EXTINGUISH THE TORCH MEETING SESSION ONE

Project: Resurfacing & Safety Upgrades of SR 91 between MM 185 - 190.5

LESSONS LEARNED

SUMMARY REPORT

- **Emergency Response Plan**

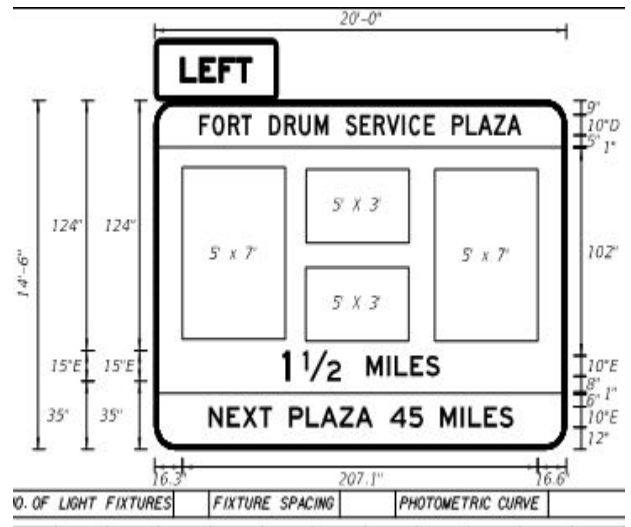
ISSUE SUMMARY: During the deep milling and resurfacing on E8Q41 Contract we encountered two base failure. These base failure caused an emergency lane closure causing as much as a 7 mile backup. The challenges came when we needed filter fabric and # 57 stone in the middle of the night or over the weekend. The concern was that a similar base failure could occur on this project.

RESOLUTION: We developed a plan to have on hand enough material readily available as a precaution measure just in case a similar failure occurred on this project.

Polymer Nosing For Bridge Deck Expansion Joint Overrun

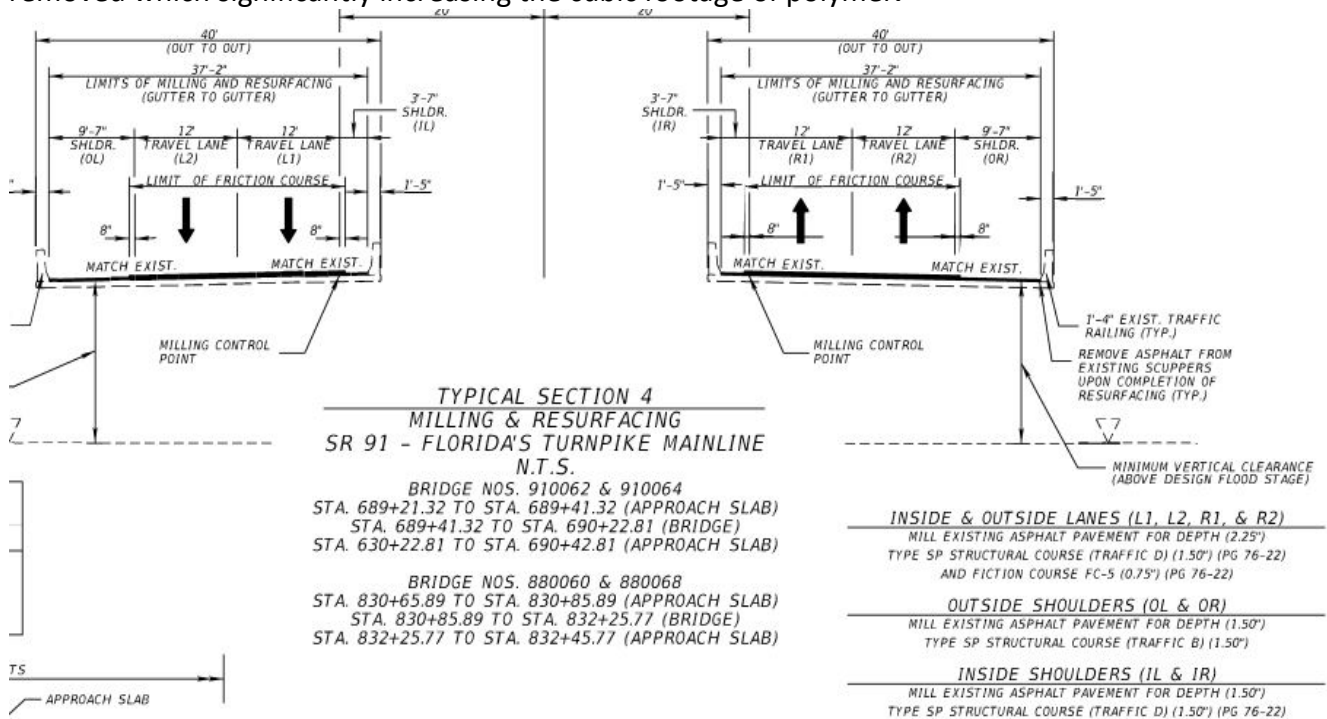
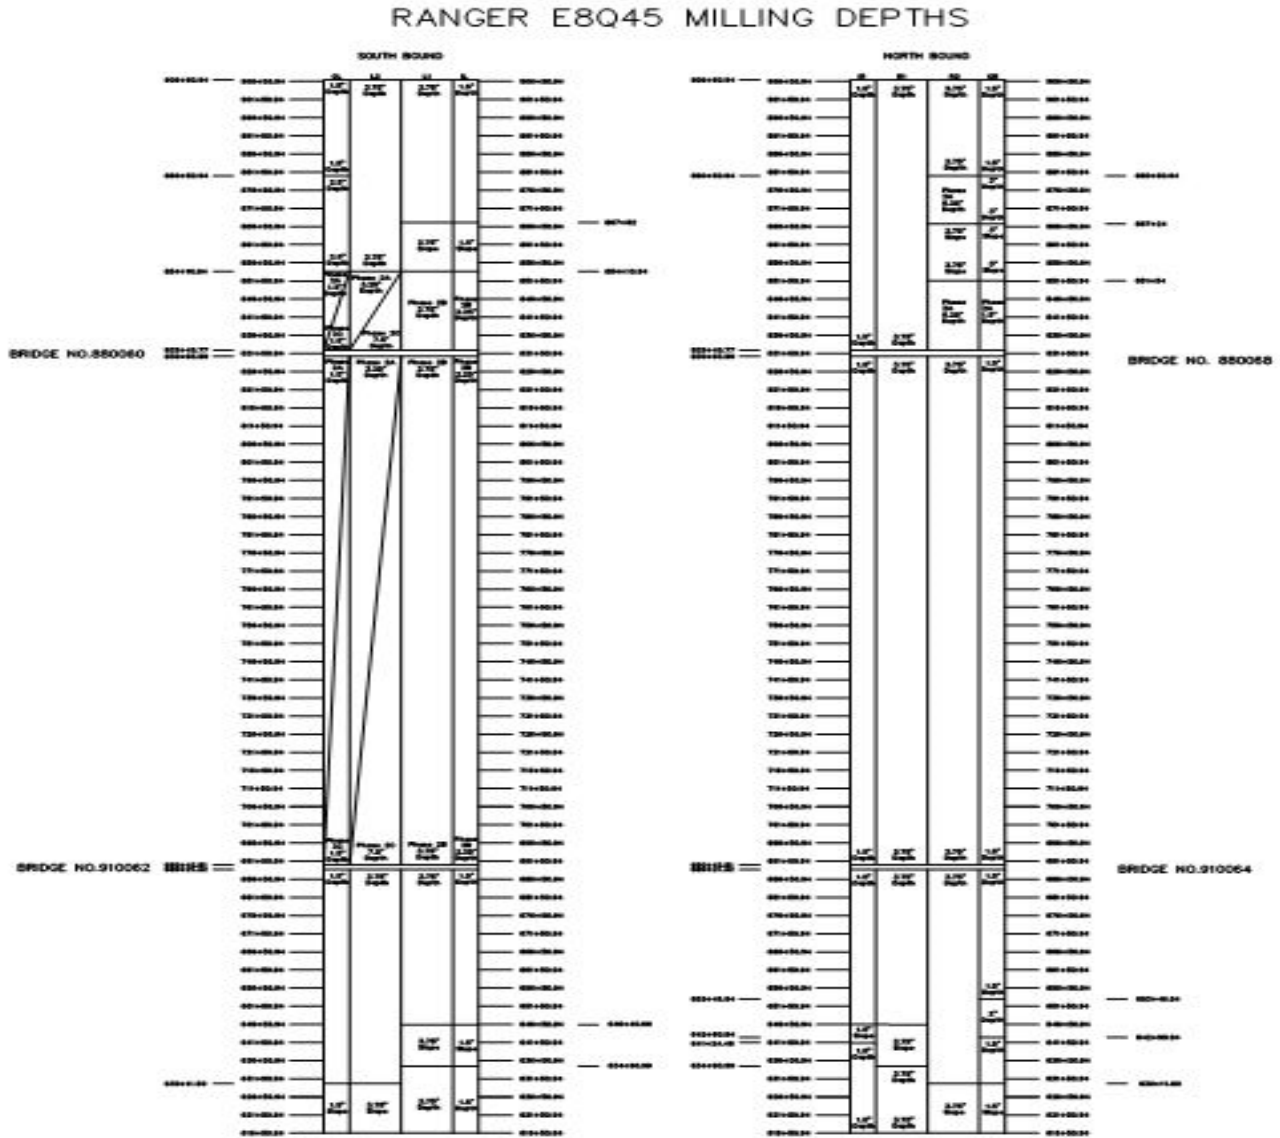
ISSUE SUMMARY: The typical sections for the bridges shows milling 2.25", over the existing asphalt was much thicker. All of the remaining asphalt within the 16" polymer nosing system had to be removed down to the bridge deck since it will not adhear to asphalt. This additional asphalt thickness had to be removed which significantly increasing the cubic footage of polymer.

Bridge joint prior to the installation of the polymer nosing system

RESOLUTION: Prior to the milling operation determine how much asphalt is on the bridge deck by drilling through the overlay. Based on this measurement you can then determine milling depth.
